Design Committee Meeting

July 16, 2026

1. Highland Reserve North Specific Plan Parcel 46B – 7Brew Coffee, 10201 Fairway Dr, File # PL26-0163

There is one outstanding issue associated with this request. Planning staff cannot make the finding that the proposed LED lighting on the roof eaves of the building meet Community Design Guidelines CC-81 and CC-86 regarding commercial lighting, and has therefore included Condition of Approval #9. This issue is discussed further in the Design Review Permit evaluation of the staff report.

Figure 3: West Elevation facing Fairway Drive

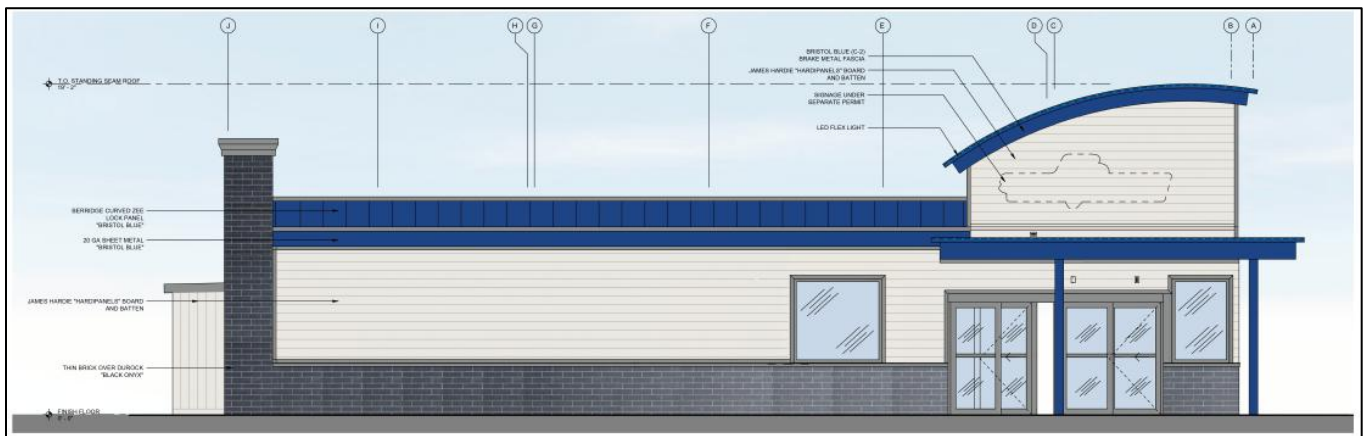
One design element that Planning staff cannot make the finding for is the proposed LED lighting along the eaves of the tower element and drive-through canopy as seen on Figure 3 and on pages A4 and A5 of the proposed plan set (see Exhibit A). CDG guideline CC-81 specifies that the “light fixtures should be compatible with the architectural style, materials, color, and scale of the project” and CC-86 states that “lighting sources shall have cut off lenses and should be located to avoid light spillage and glare on the adjacent properties and in private spaces.” The proposed LED lighting is unshielded and would create an incongruous and obtrusive visual distraction on the building and within the center. The applicant disagreed with staff’s assessment and stated they would prefer that the Design Committee make the determination on appropriateness of the design feature. For that reason, staff recommends Condition of Approval #9, that specifies that the proposed LED lighting must be shielded by an architectural feature of the building, preferably located on the underside of the eaves.

9. The proposed LED flex lights as shown on Exhibit A shall be shielded from direct public view, through integration into the underside of the roof eaves or by other means as deemed appropriate by the Planning Manager. (Planning)

Figure 4: South Elevation facing internal drive aisle

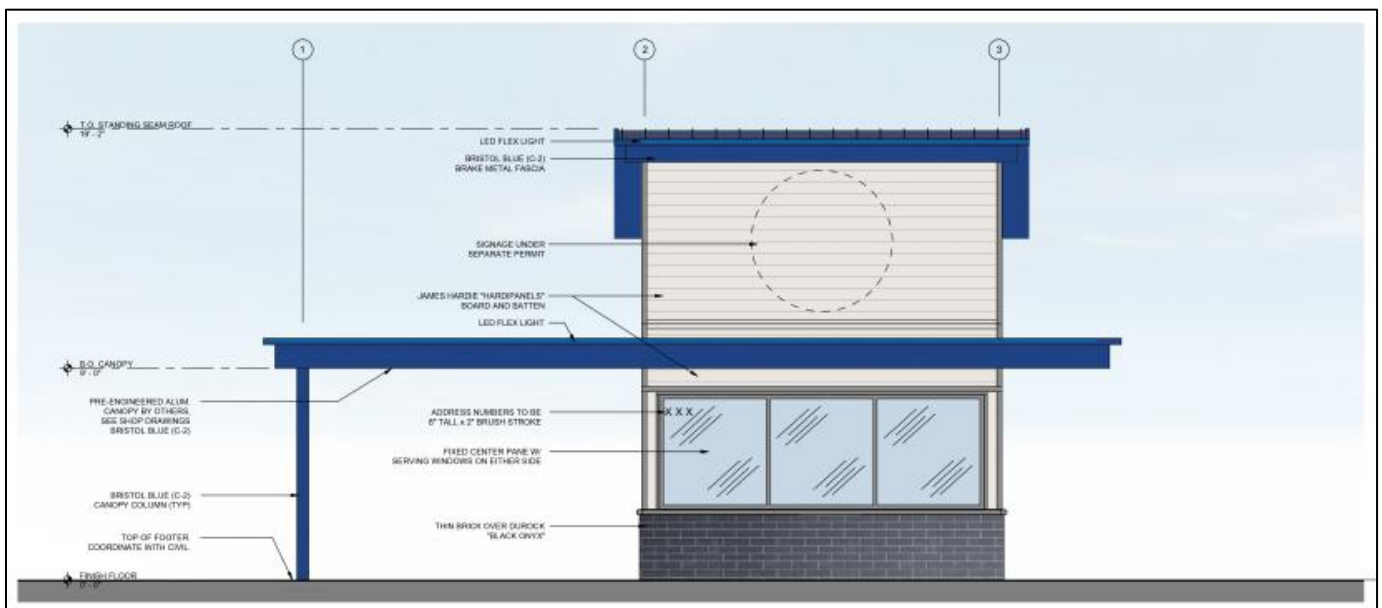
As demonstrated in the elevations above, the building is well articulated with a variety of building heights, wall planes, and roof forms as called for by the CDG. Overall, with the addition of Condition of Approval #9, the building design is harmonious with the surrounding development and meets the intent of the CDG by using a mix of colors and materials, architectural elements, and articulation in the façade.
